Preliminary Plan 120090300, Boyds Highlands

Staff Report Date: 01/18/13

Preliminary Plan 120090300: Boyds Highlands

A request to resubdivide an existing lot into three lots for three one-family detached units on 11.01 acres of land in the RE-2 Zone. Located on the north side of Barnesville Road (MD 117), approximately 950 feet southeast of Slidell Road, in the Boyds Master Plan area.

**Figure B
Preliminary Plan**

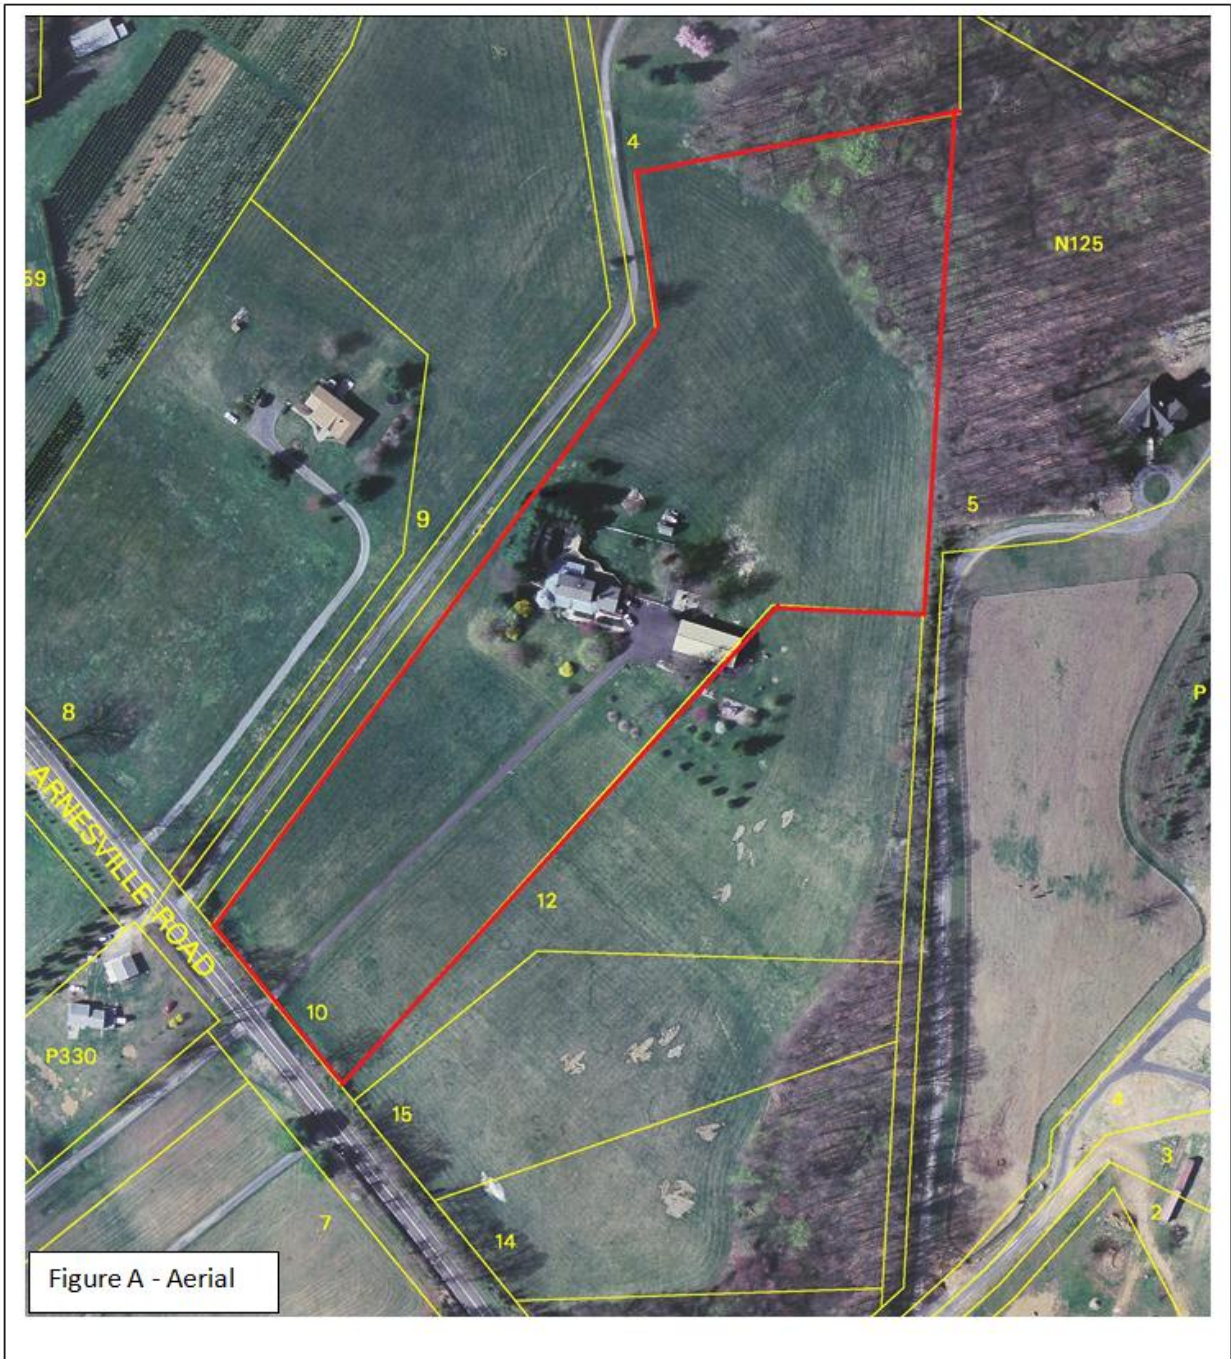
- The sight distance of the proposed driveway for Lot 18 is significantly substandard and creates safety concerns. This driveway must either be relocated to a safer location, the substandard condition must be mitigated for or it should be eliminated and access combined with the other driveway. This must be addressed before this office will issue an approval.
- A permit will be required from the District 3 Utilities office for this project.
- The shared driveway should be 20' wide with 10' radii.

1. The record plat must be at the same scale as the preliminary plan, or submit an enlargement of the plat to match the preliminary plan.
2. The record plat must show the septic reserve areas as they are shown on this plan.

Comments: No changes would be allowed to the existing garage because it appears to have a non conforming setback.

- 7) Prior to recordation of a record plat, the Applicant must have the stormwater management concept recertified by MCDPS.
- 8) The record plat must reflect an ingress/egress and public utilities easement thirty feet in width along the shared driveway.

Figure D – Preliminary Forest Conservation Plan

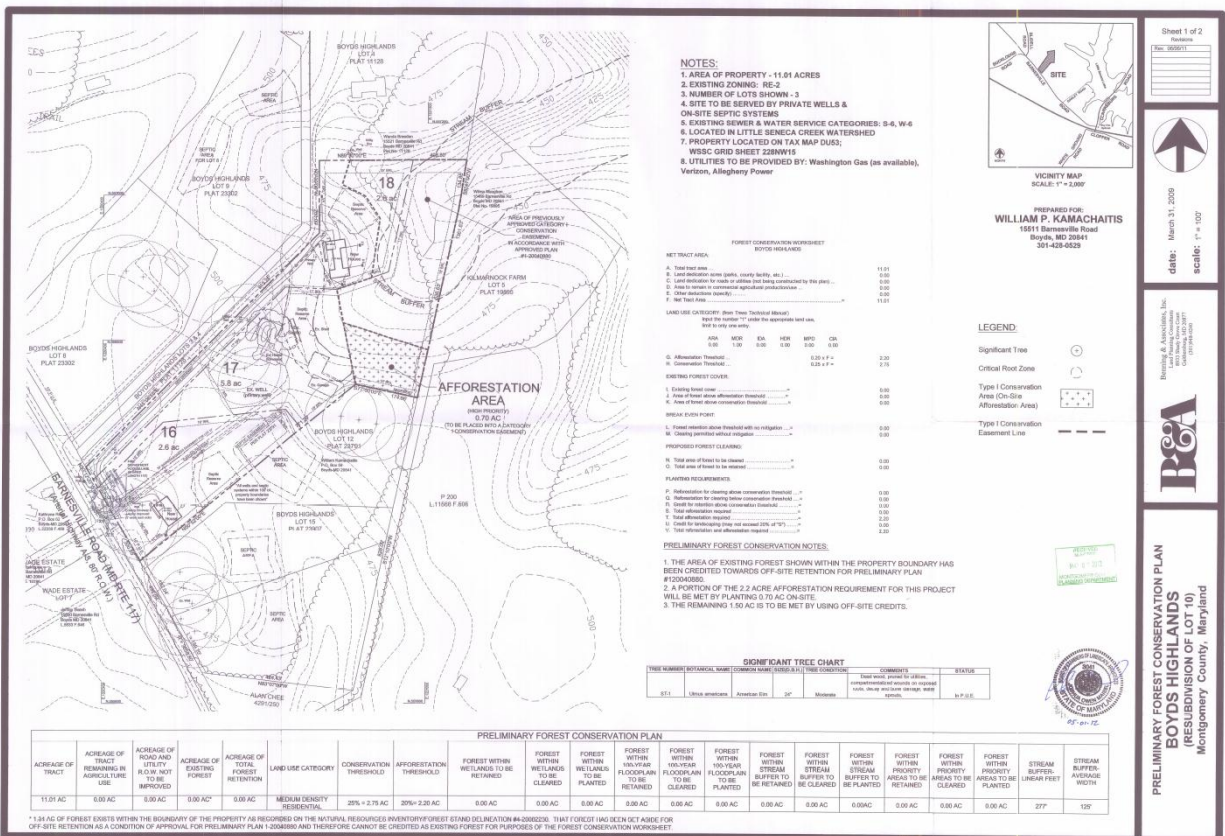
Development of the Property generates a 2.20 acre afforestation planting requirement because the Property contains no existing forest and under the Medium Density Residential land use category, the Property has a 20 % afforestation threshold for the net tract area. The Applicant proposes to meet the planting requirement through a combination of 1.5 acres of off-site mitigation bank credits and 0.70 acres of onsite afforestation that will be protected in a Category I easement on proposed Lot 17. Sensitive environmental features on the Property are adequately protected and the Application complies with Chapter 22A, the Montgomery County Forest Conservation Law.

- a) The Applicant must obtain approval of a Final Forest Conservation Plan from the Planning Department prior to the issuance of a Sediment Control Permit from the Montgomery County Department of Permitting Services. The Final Forest Conservation Plan must be consistent with the approved Preliminary Forest Conservation Plan.
